Western States Petroleum Association
Credible Solutions • Responsive Service • Since 1907

May 22, 2015

Re: WSPA Comments on draft Regulation for Greenhouse Gas Emission Standards for Crude Oil and Natural Gas Operations – Second Round

Figure 5.2.1.1: Leak Rates vs. Screening Values of All Leaking Components

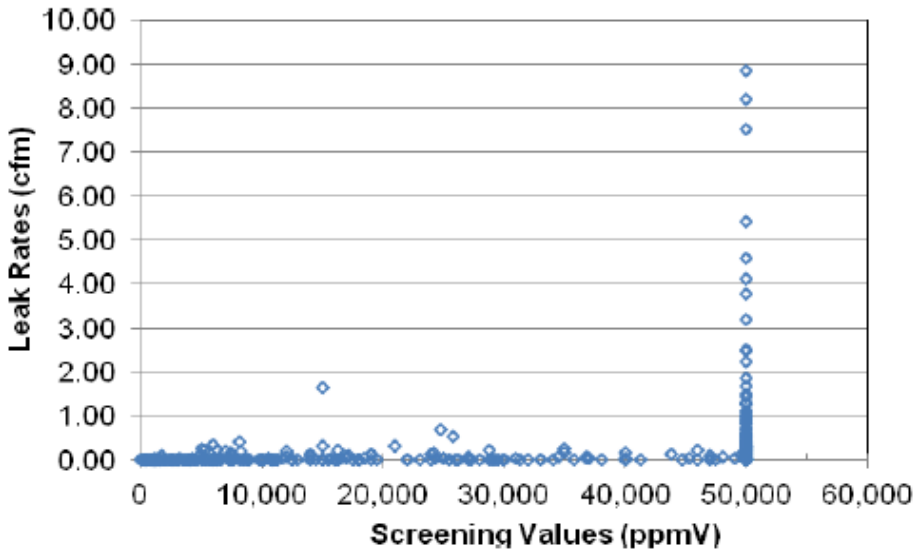
There is no technical basis for the assumption that a leak threshold below 10,000 ppm will result in significant emission reductions. In a study performed by California State University Fullerton (CSUF) under a California Energy Commission Project, it was clearly illustrated that there is no correlation between ppm determined through Method 21 and leak flow. Figure 5.2.1.1 of the

CSUF report provides a graph representing the concentration vs. leak rate data collected. The same data is separated into concentration ranges in Table 5.2.1.2. The Figure and Table are included below:

As seen in the table above, greater than a 90% reduction would result from the control of leaks above 50,000 ppm. If 10,000 ppm were to be selected as the threshold, greater than a 97% reduction would be realized. Conversely, a ppm threshold of 1,000 ppm would only result in less than 2.7% additional emissions capture beyond a 10,000 ppm cutoff and an additional drop to 500 ppm, as suggested by some stakeholders in ARB workshops, is effectively negligible.

As shown through these calculations, a ppm threshold below 10,000 ppm is not an effective method for emissions reduction nor is it cost effective due to the compliance costs associated with an LDAR program as discussed above. Therefore, most existing regulations consider 10,000 PPM as the threshold. Below is a table of comparison of existing regulatory leak thresholds:

In order to improve cost-effectiveness, minimize the burden on operators and align with existing major regulations, WSPA recommends that ARB define a leak at 10,000 PPM and a major leak at 50,000 PPM for facilities that are subject to existing local air district LDAR programs.

Figure 1. Typical high level steps involved in California's oil well completion activities with well stimulation treatments.

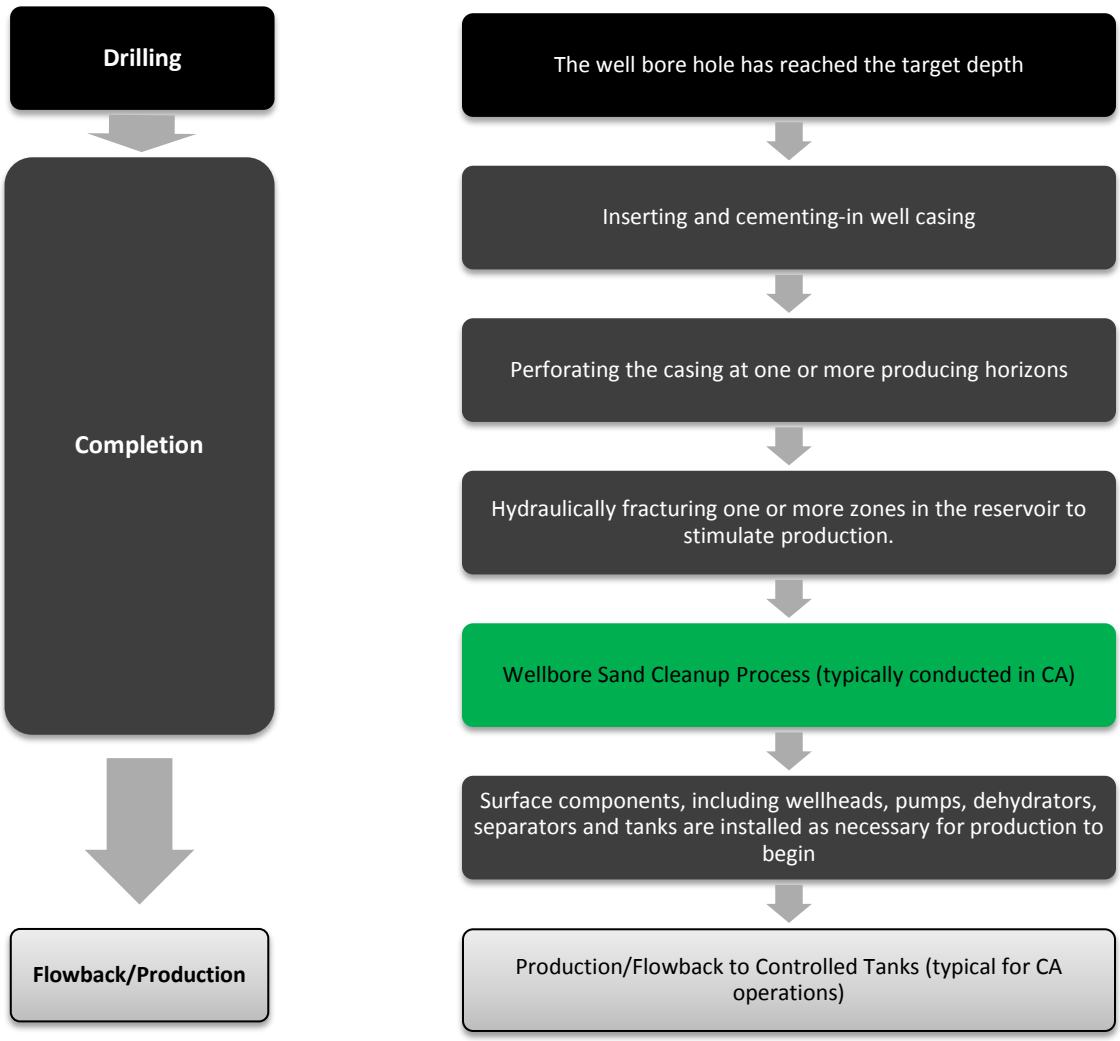
In order to accurately quantify the emissions from circulation tanks used in well stimulation treatments, it is critical to understand the processes in which the circulation tanks are used and differences from processes described in some other studies (e.g., USEPA White Paper on Oil Well Completions). During the Methane Rule Workshops held by ARB on April 27 and 29, 2015, several stakeholders were confused on ARB's intent to control circulation tanks and incorrectly assumed that ARB was trying to control emissions from flowback. WSPA is providing the description below to help clarify ARB's intent of controlling circulation tanks and associated emissions. A typical well stimulation treatment follows the steps described in Figure 1.

Typically, in non-California operations (as described in USEPA white paper for oil completions with hydraulic fracturing) the flowback[1] from the hydraulically fractured wells is directed to open tanks or pits. ***However, California operators normally direct production flowback into the existing and permanent production tank systems that are typically required to have vapor recovery systems.*** These systems, which the proposed regulation addresses separately, have overall capture and control efficiency rates ranging from 90% to 99.5%. The gas can be combined with fuel streams either for combustion, further gas processing, gas injection, or gas sales. Since these activities meet the definition of Reduced Emissions Completions (RECs) in the USEPA white paper, most California hydraulically fractured oil well completions are RECs or green completions.

California's oil fields generally produce very little gas (an average of 6 – 10 scf/bbl) due to low reservoir pressures, preventing the reservoir fluids from entering the wellbore without a lifting mechanism. As a result, operators have to conduct additional steps during oil well completions following well stimulation treatments (the wellbore sand cleanup process). This process is carried out separately prior to the flowback/production phase in order to clean out the sand from the wellbore. This separate process is unique to oil production fields where the reservoir pressures are very low and/or the gas to oil ratio (GOR) is very small. This is in contrast to fields with a higher GOR because the pressure in these wells will carry the sand out of the well without the need for the separate wellbore sand cleanup process.

During the wellbore sand cleanup process, the well is balanced or over-balanced to prevent the reservoir fluids from entering the wellbore. This means that the wellbore is kept at a pressure at or above the geologic formation pressure by the weight of the fluids circulated into the wellbore. A mixture of fresh or produced water is circulated into the wellbore and the sand is lifted and pumped out. A small temporary portable tank is used during this process to circulate the water and to separate the sand from the water. After the wellbore cleanup process is complete, the well is put into production during which the flowback and production are directed to controlled permanent tank systems as described above.

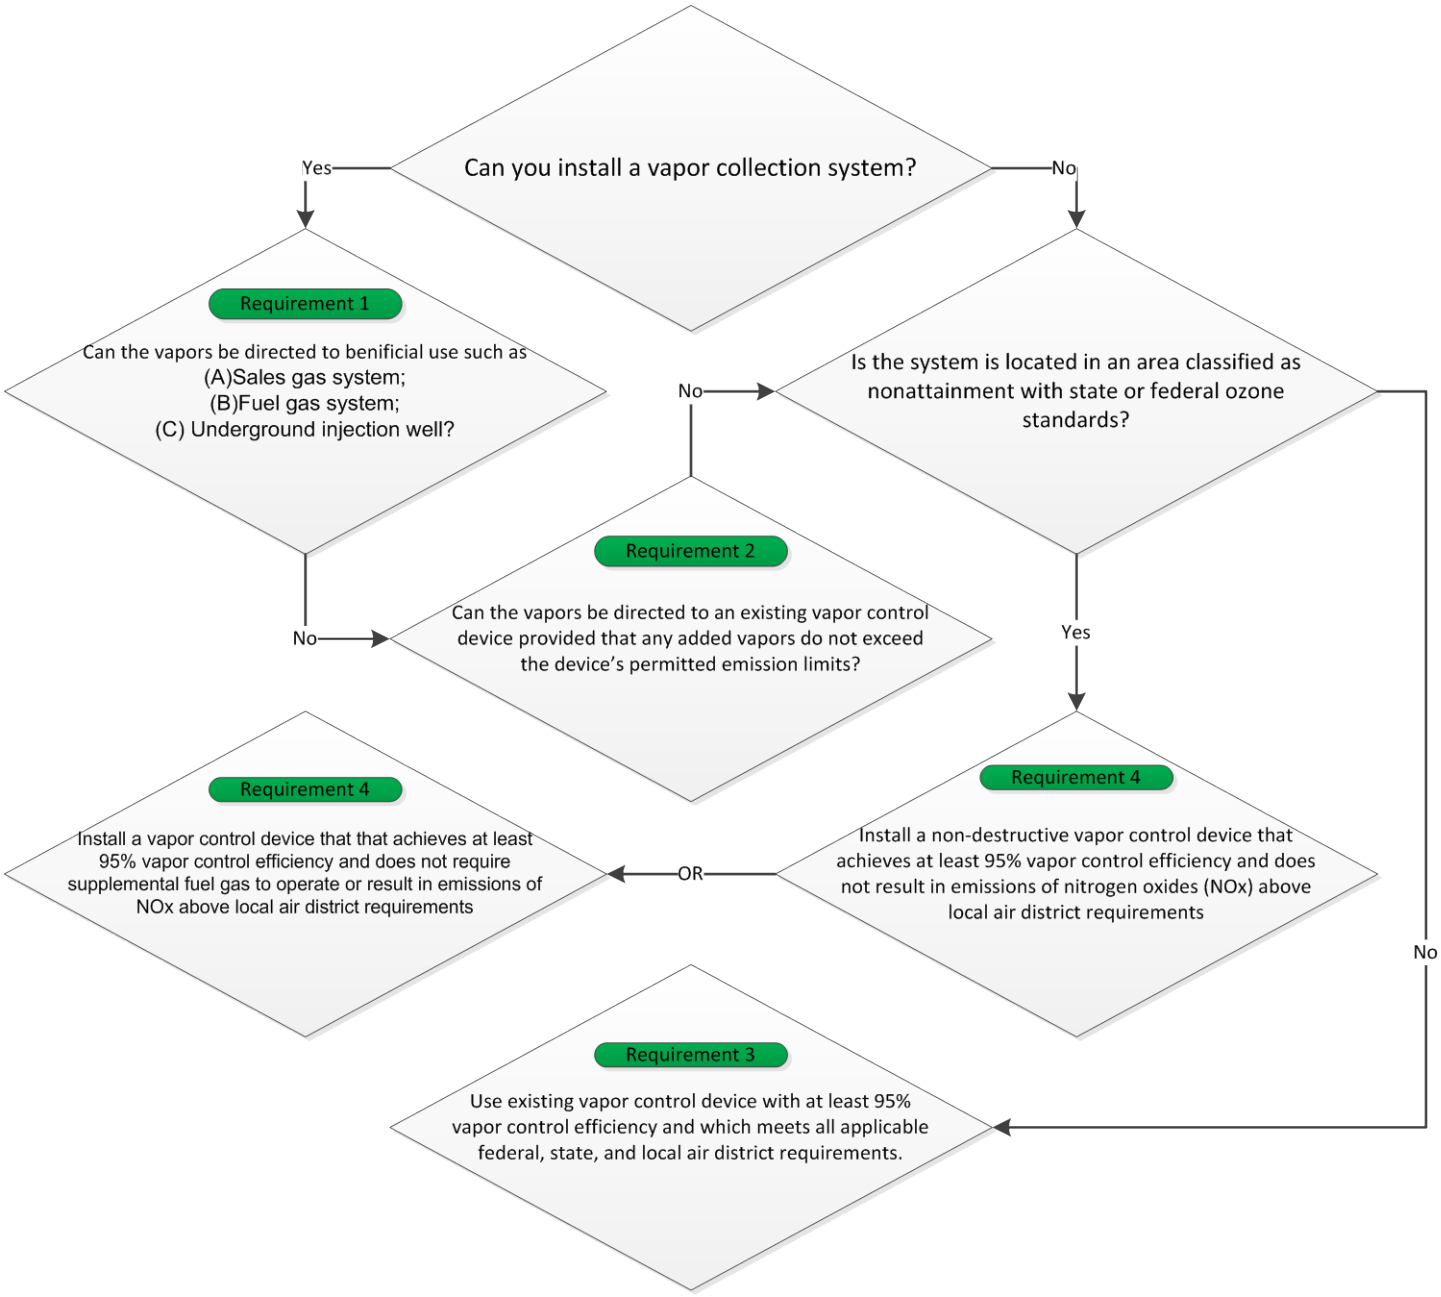
The proposed regulation identifies four control requirements for the temporary portable circulation tanks in the order of technical feasibility. These requirements are described in the following diagram.

As shown in the diagram, the requirements apply to all wellbore cleanup events regardless of the emissions from each event. WSPA is concerned about the technical feasibility of the proposed control technologies.

None of the control technologies proposed above can be technologically achievable for most of the events taking place in California. The current proposed regulation has not considered the possibility of not being able to implement the options of control listed in Section 95213(c), especially where the gas volumes are low and fluctuating. As noted above, there are no existing control technologies that are proven to provide 95% capture and control of emissions from circulation tanks. The proposed “new” systems from vendors are yet to be tested or used in wellbore sand cleanup process and there are no guarantees that those systems will achieve the proposed capture and control requirements.

Alternative Methods of Control: As the current proposed regulation has not considered the possibility of not being able to implement the options of control listed in Section 95213(c), WSPA suggests that ARB consider adding to the regulatory language an alternative method of controlling emissions for events that are below 10 MT CH_4 and those events where none of the proposed control technologies would be feasible. WSPA is suggesting the development and implementation of a Best Practices Management Plan (BMP) as an alternative method of control. Some of the best practices that can be implemented including but not limited to:

WSPA recommends that ARB allow operators to develop and implement a BMP and to demonstrate how the emissions are minimized for each event.

Example 1

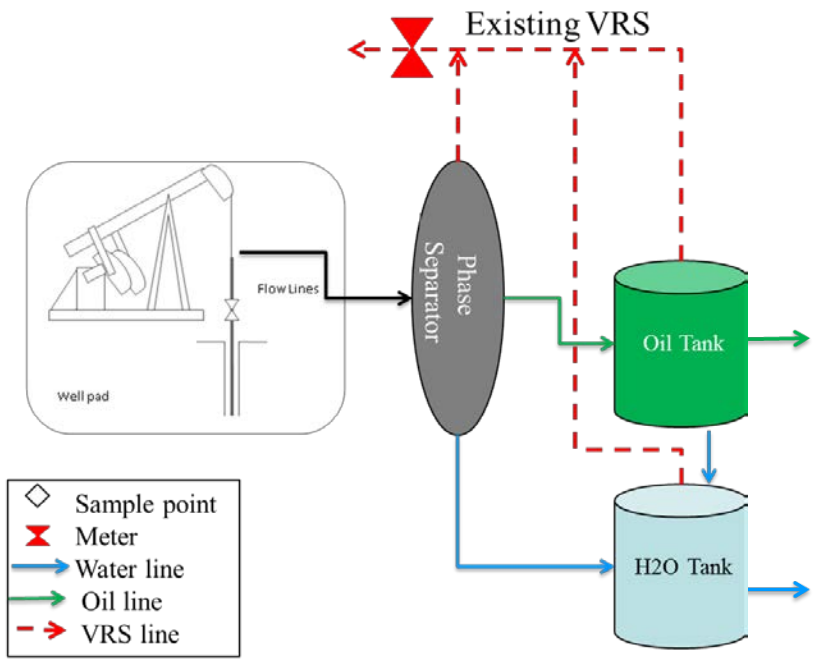
WSPA understands that Example 1 configuration would not be subject to any of the proposed requirements in the regulation since the first vessel (Phase Separator) and the second vessels (Oil and Water tanks) following a well on the crude oil and produced water lines are already under vapor recovery.

Example 2

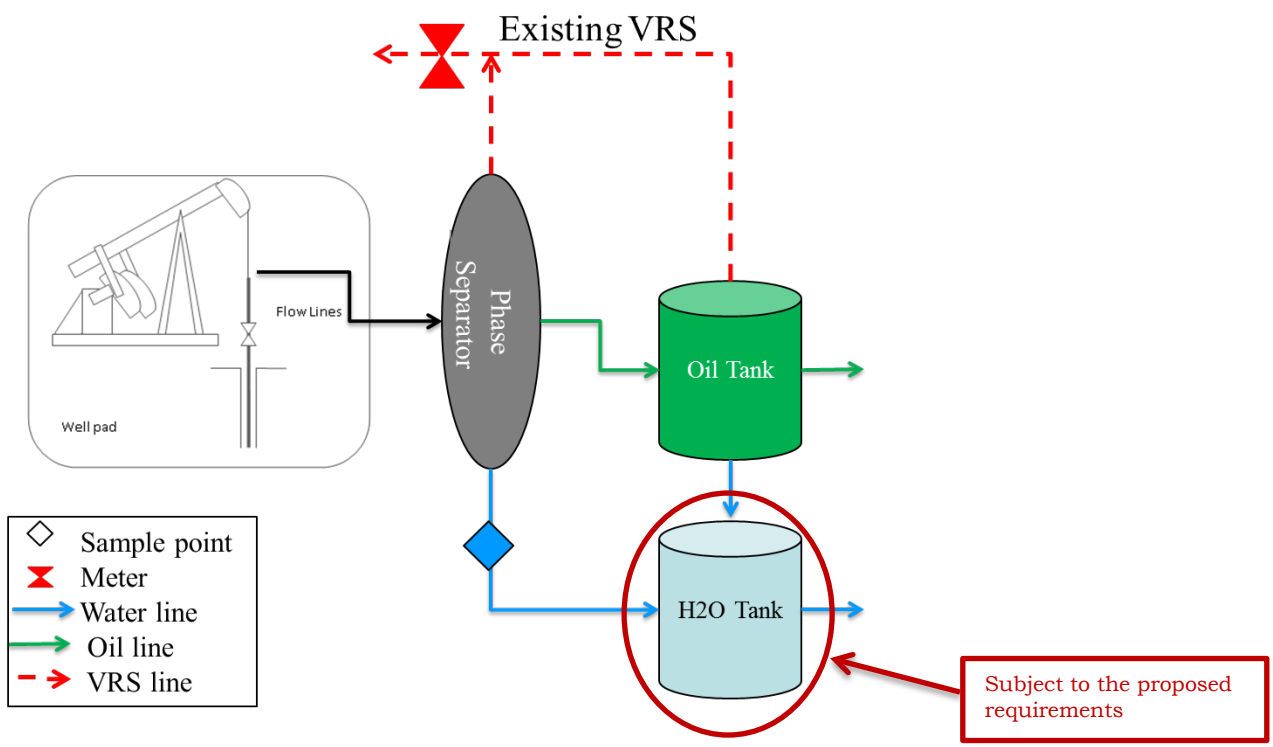
WSPA understands that in the Example 2 configuration shown below, only the identified produced water tank would be subject to the proposed requirements of the regulation.

Example 3

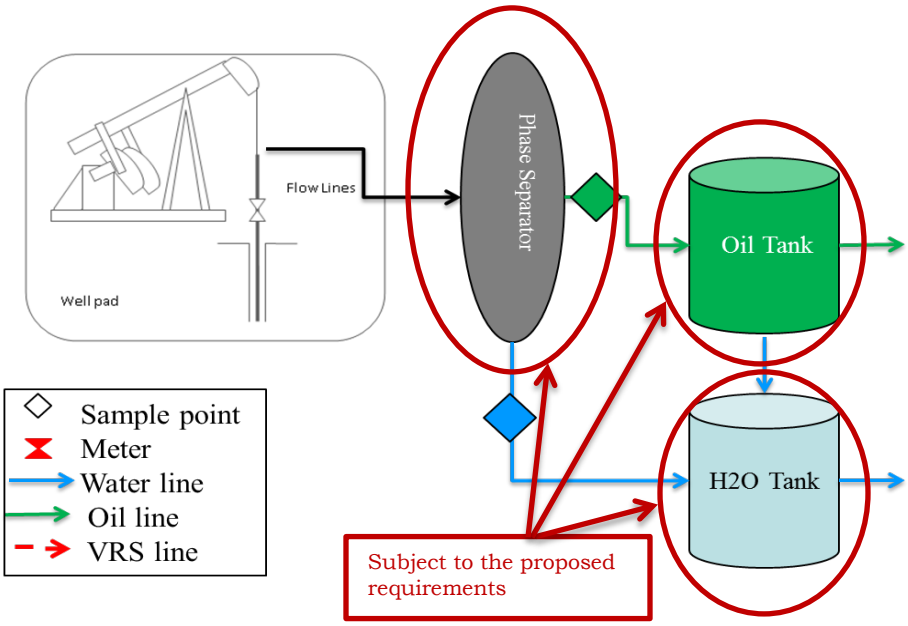
WSPA understands that in the Example 3 configuration shown below, the identified phase separator, oil tank, and produced water tank would be subject to the proposed requirements of the regulation.

Example 4

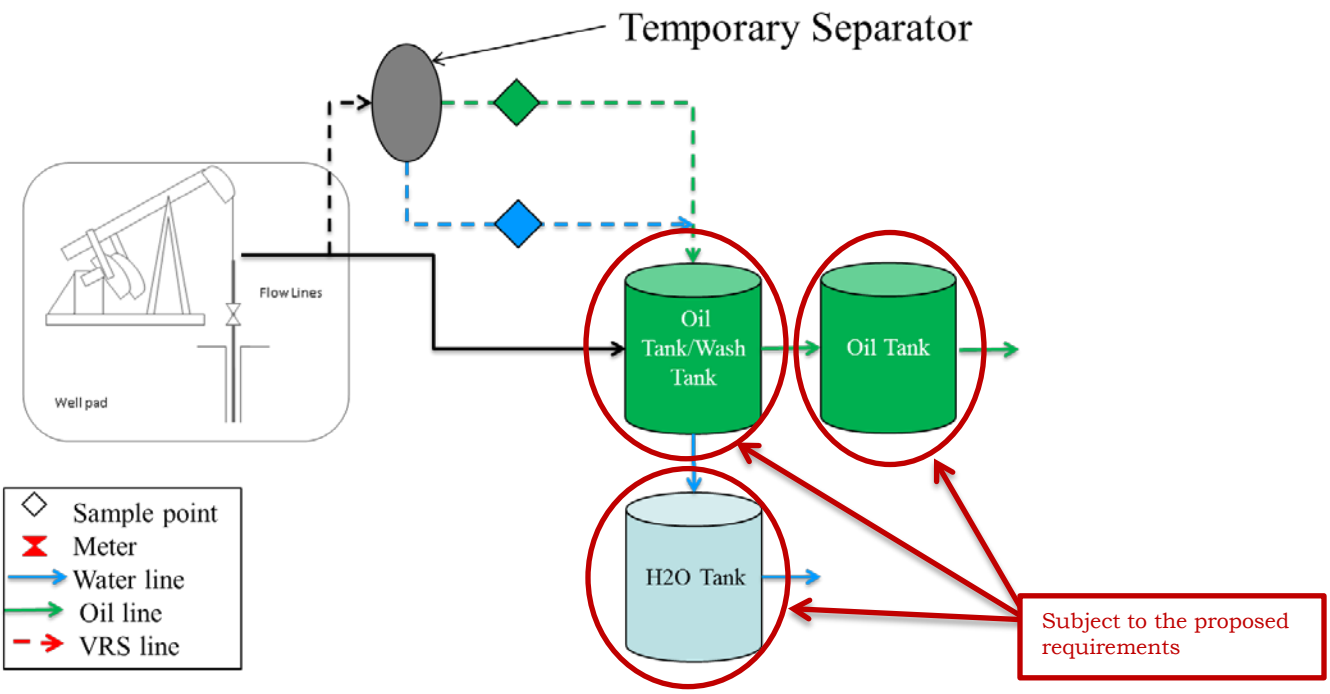
WSPA understands that in the Example 4 configuration shown below, the identified oil tanks and produced water tanks would be subject to the proposed requirements of the regulation.
